1 INTRODUCTION

1.1.1 Velocity Transport Planning (VTP) has been appointed by Firethorn Trust (the Applicant) to provide highways and transport planning advice for an outline planning application relating to the development of up to 530 dwellings on land which forms part of the North West Bicester Eco Town development, located in Oxfordshire.

1.1.3 The Proposed Firethorn Development description for the outline planning application (planning ref 21/01630/OUT), is as follows:

1.3.1 This TN has been prepared to provide comprehensive responses to those consultees identified above and to provide further clarity and/or additional information that has been identified through the review of these consultation responses and following post-submission meetings.

Figure 3-2: Local Amenities in proximity to the Application Site

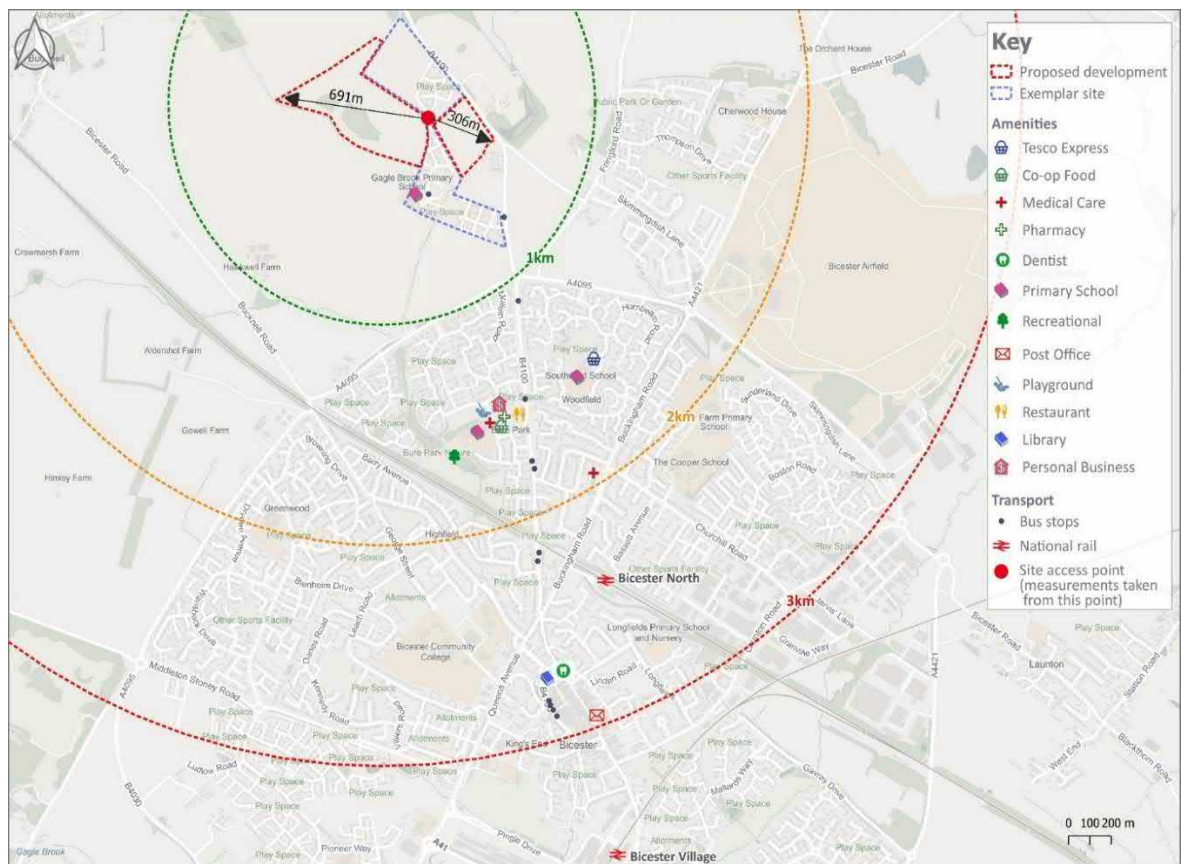
- 3.6.1 The distances to local facilities have been reviewed, and **Figure 3-2**, provided below, identifies the location from where the measurements have been taken more clearly. It is acknowledged that this location was not identified on the plan included within the TA, and in fact, the measurements were taken from the junction of Charlotte Avenue with the B4100, which is not relative to the application site.
- 3.6.2 In addition to the updated measurements, the starting point of the calculations, which is located between the eastern and western parcels, is identified as being approximately 300m from the easternmost point of the eastern parcel and approximately 700m from the westernmost point of the western parcel. The internal layouts of these parcels have not been agreed upon yet, but hopefully, this provides a little more clarity.

Figure 3-3: Cycle Routes in Bicester

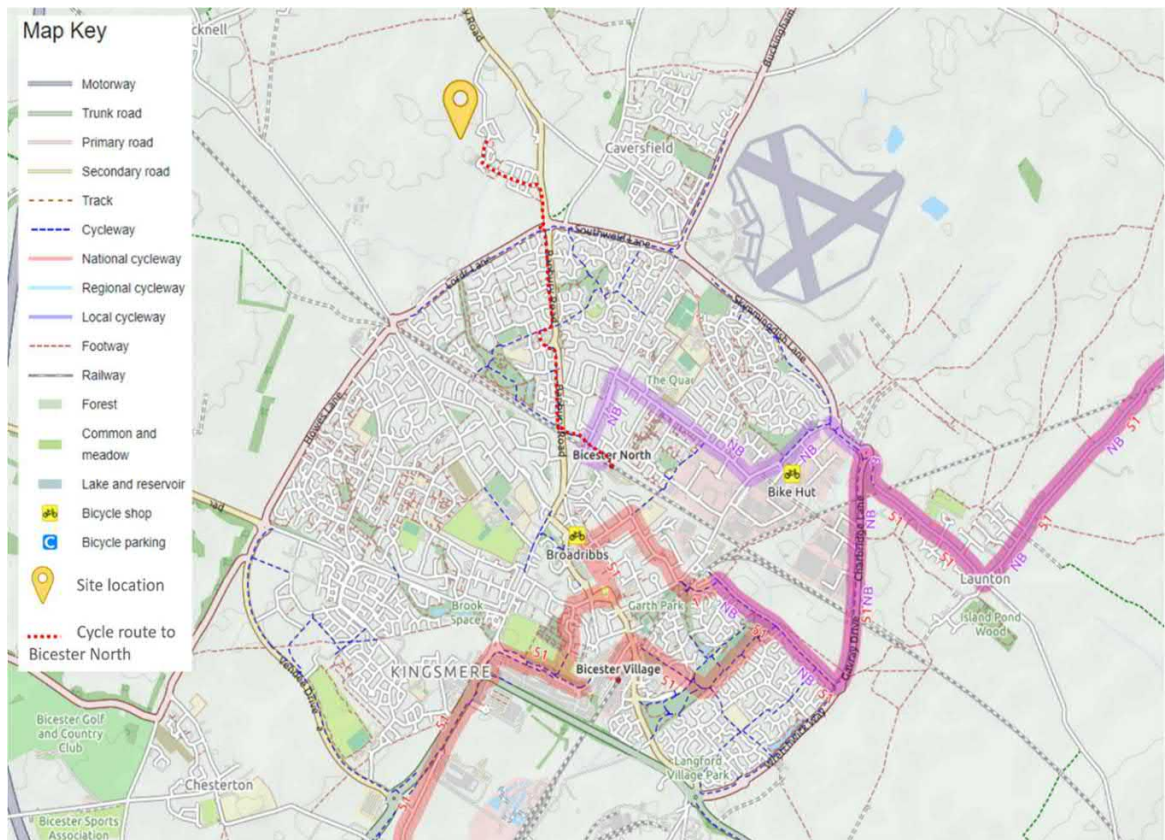
- 3.6.8 It is acknowledged that the route may not currently comply with Local Transport Note (LTN) 1/20 ‘*Cycle Infrastructure Design*’, particularly in terms of the appropriate width requirements, but this is considered to be due to the fact that the route precedes the development of the LTN 1/20 guidance. It is also noted that there may be a need to utilise crossing facilities to cross the roads, but nevertheless, the vast majority of the route remains off-carriageway.

3.6.9 **Figure 3-3** highlights the cycle routes in Bicester, with the link from the application site to Bicester North railway station identified.

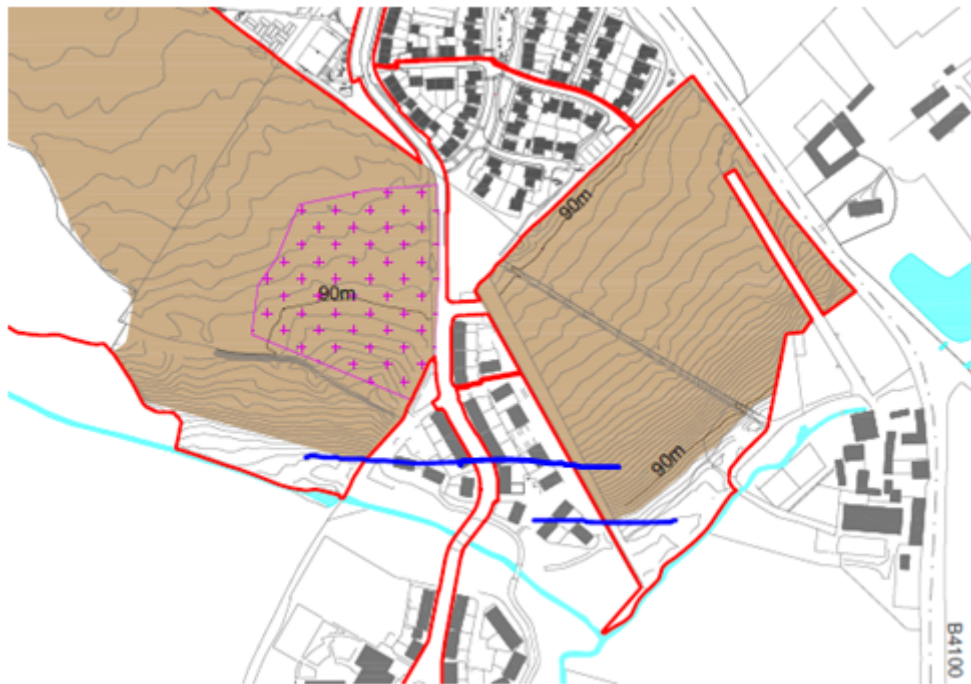
I wonder if the broad location of play space should be provided for on the Landscape Parameter plan with the form of each play area so that this is suitably secured (as well as via the S106).
